SUBJECT: PLANS AND PROPOSAL ADDENDUMS
PROJECT: STP 2023 (675)MM CONTROL: 1433-02-044
COUNTY: COMAL
LETTING: 05/04/2023
REFERENCE NO: 0419

PROPOSAL ADDENDUMS

DESCRIPTION OF ABOVE CHANGES
(INCLUDING PLANS SHEET CHANGES)

DATE: 04/19/2023 04:34 PM
 FILE: \\txdot\project\wiseonline.com\TXDOT14\Documents\15 - SAT\Design Projects\143302044\4 - Design\Plan Set\2 - TCP\Structure Layouts\CrossingE\Step2.dwg

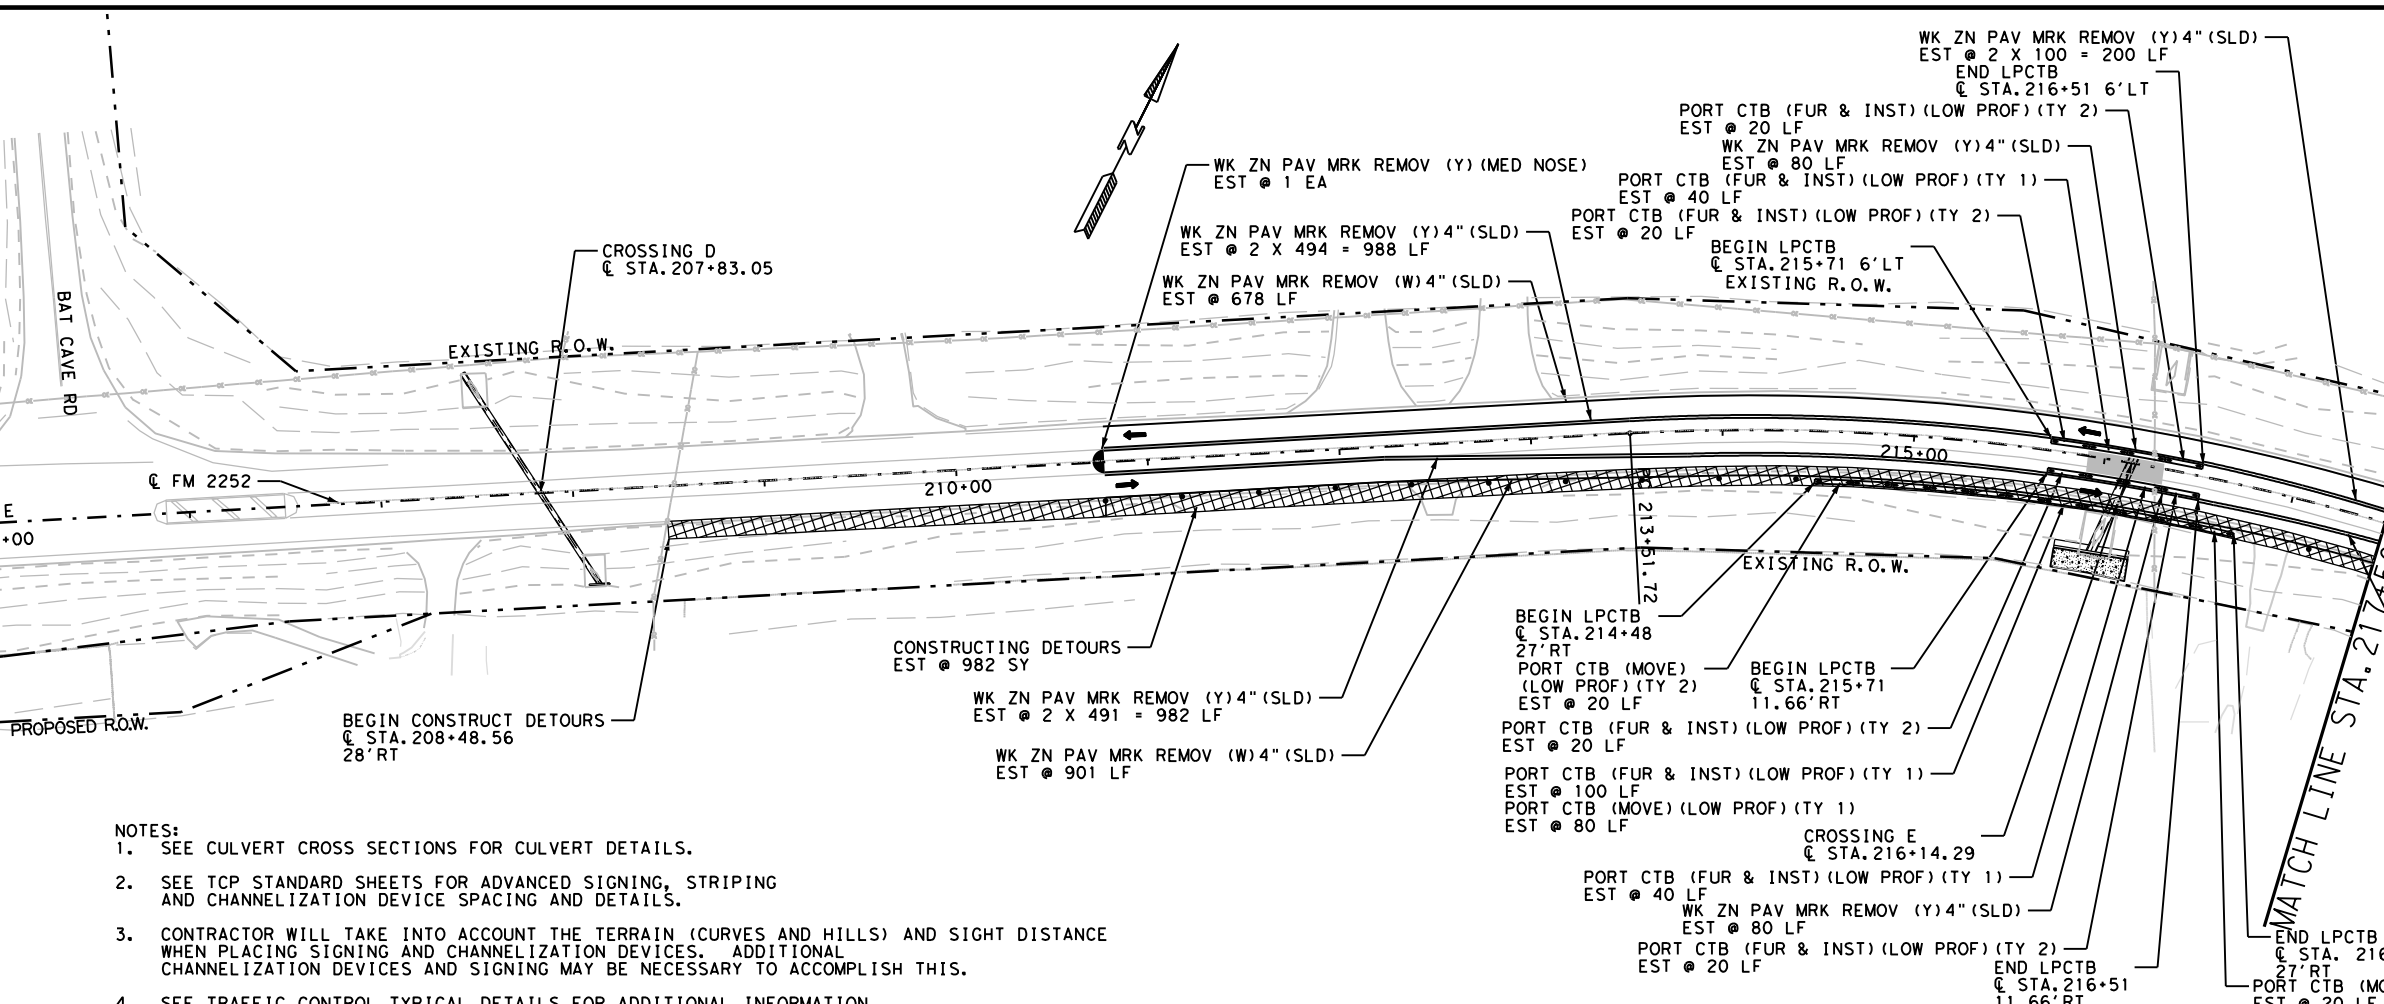
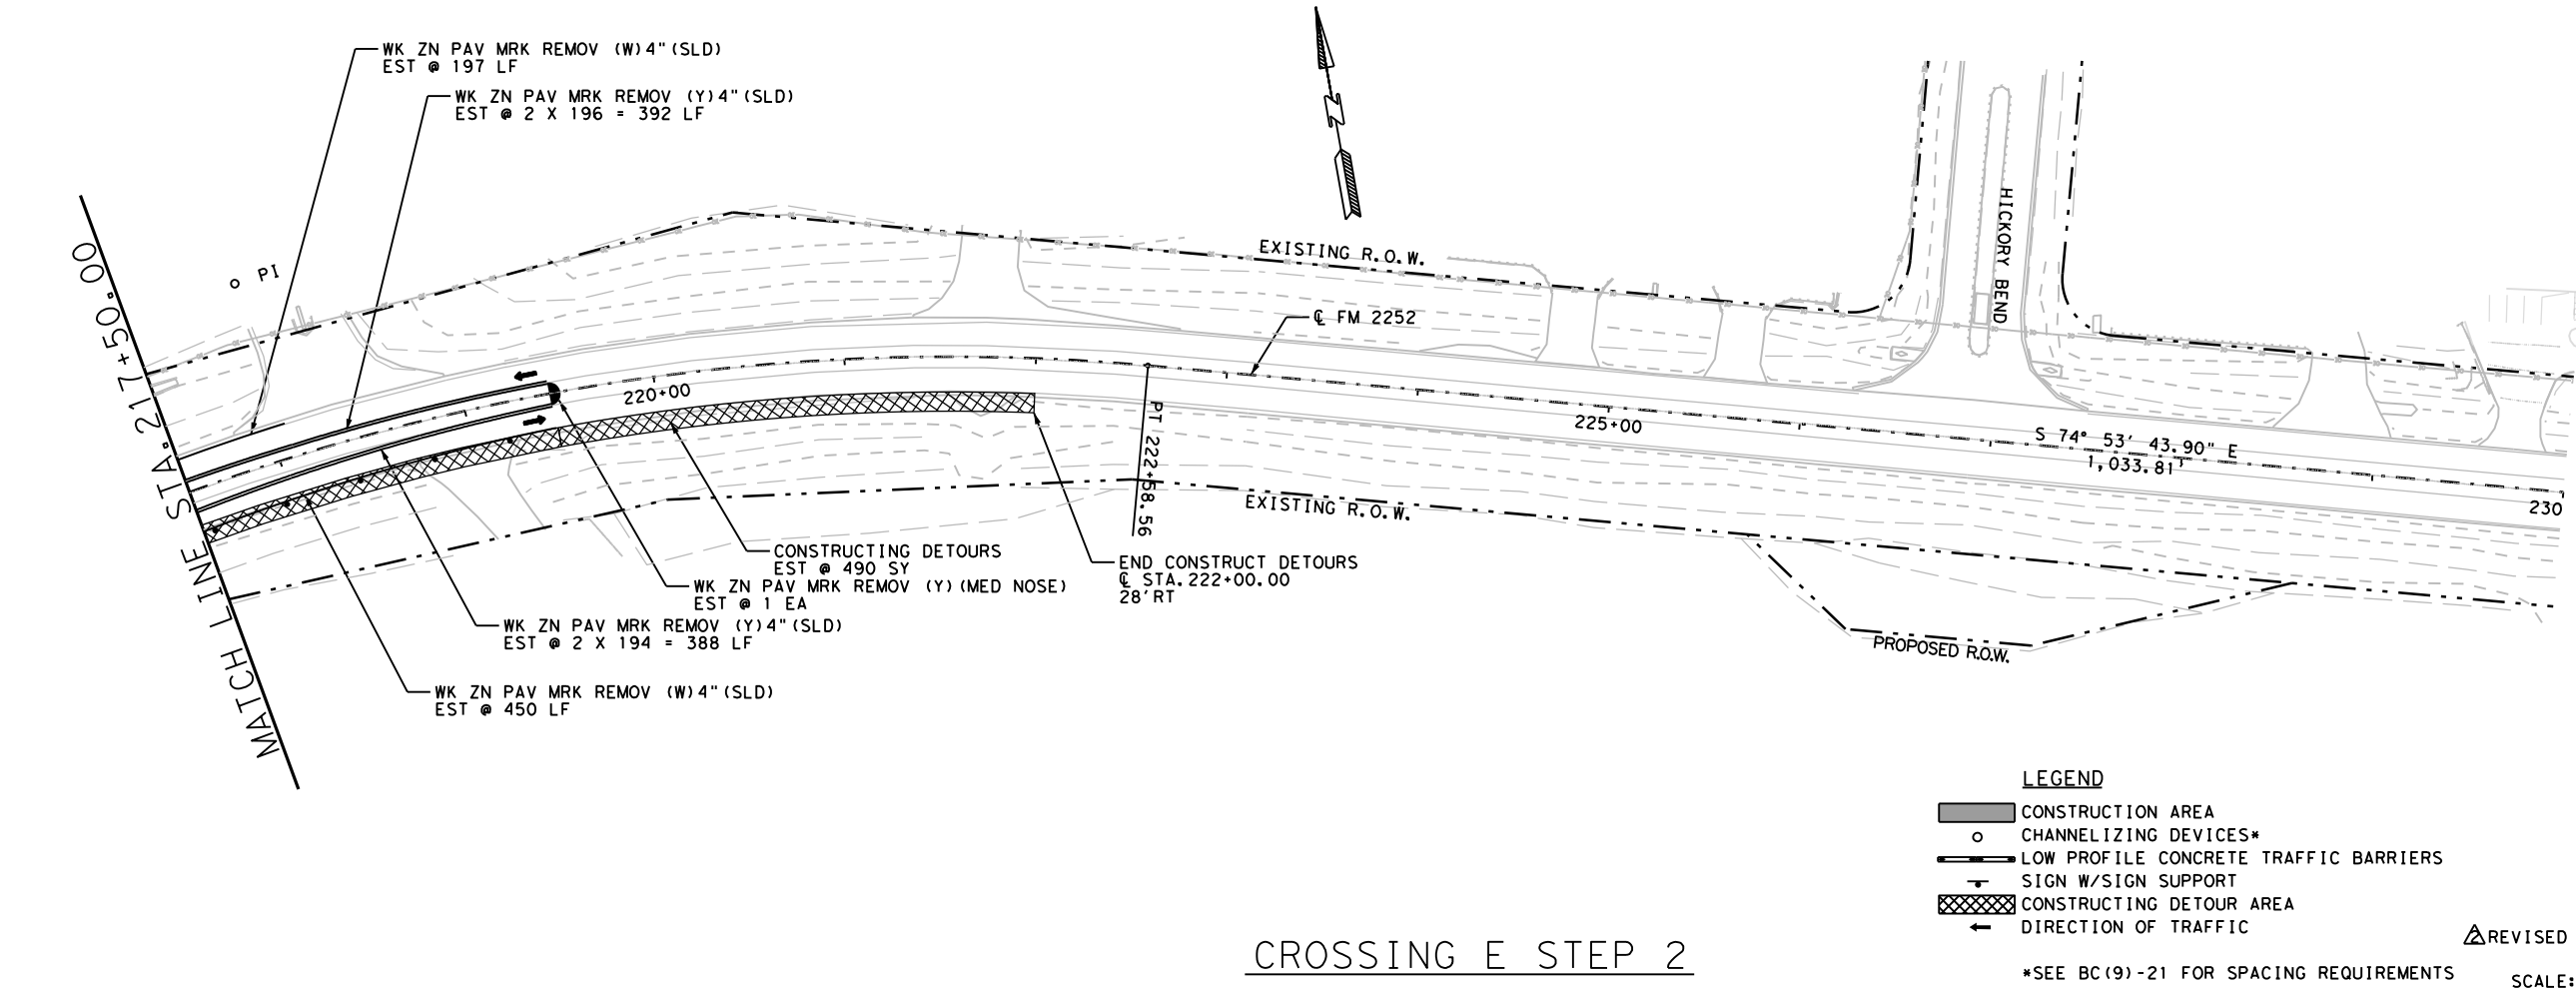
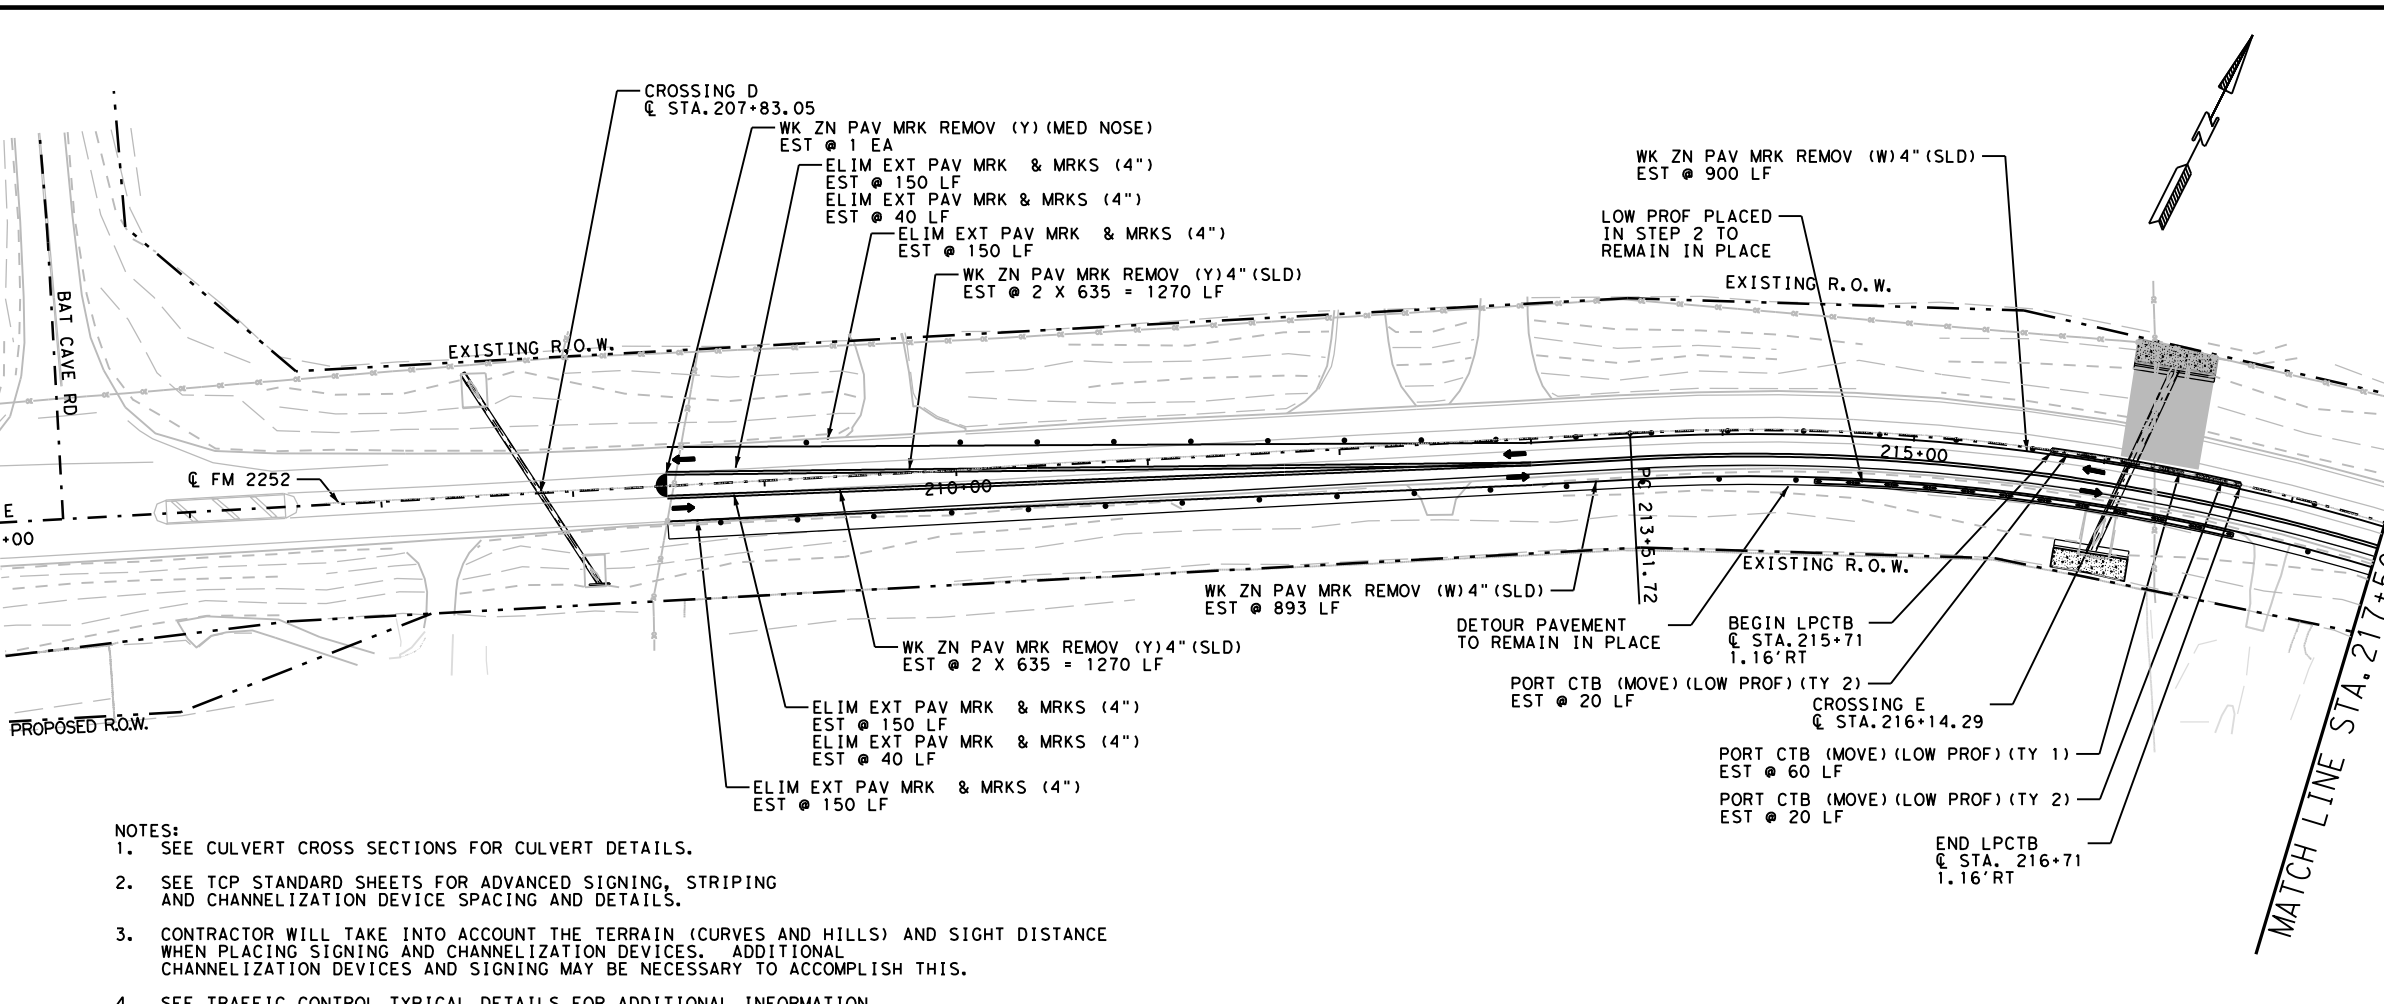
SHEETS 275-278, 280-283, 285-288 AND 290-293: ADDED ITEM NO. 403-6001
